**KAWARTHA PINE RIDGE DISTRICT SCHOOL BOARD  
PUR24-069-ITT  
Grafton Public School Classroom Upgrades**

**ADDENDUM NO. 4**

**Add:** Addendum Form, Pinchin File No. 335495.019, prepared by Pinchin, (3 page)

PROJECT NAME: SCOPE OF WORK	
CLIENT NAME: KAWARTHA PINE RIDGE DISTRICT SCHOOL BOARD	
PROJECT LOCATION: GRAFTON PUBLIC SCHOOL, 654 STATION ROAD, GRAFTON, ONTARIO	
FIGURE NAME: GROUND FLOOR	
PROJECT NUMBER: 335495.019	SCALE: NOT TO SCALE
DRAWN BY: MD	REVIEWED BY: WA
DATE: APR 2024	FIGURE NUMBER: HM-01

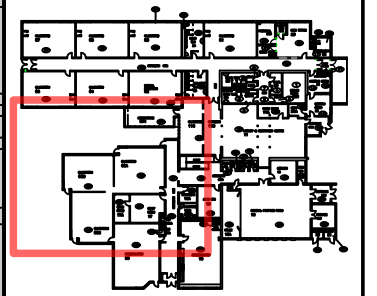
- .1 DRAWING HM-01
  - .1 Remove and replace HM-01 with the attached drawing, containing the following changes:
    - .1 Rename location “CLASSROOM 08” to “CLASSROOM 08B”.
    - .2 Rename location “CLASSROOM 08B” to “CLASSROOM 08C”.
    - .3 Highlighted additional scope in Corridor H05 (Location 47).
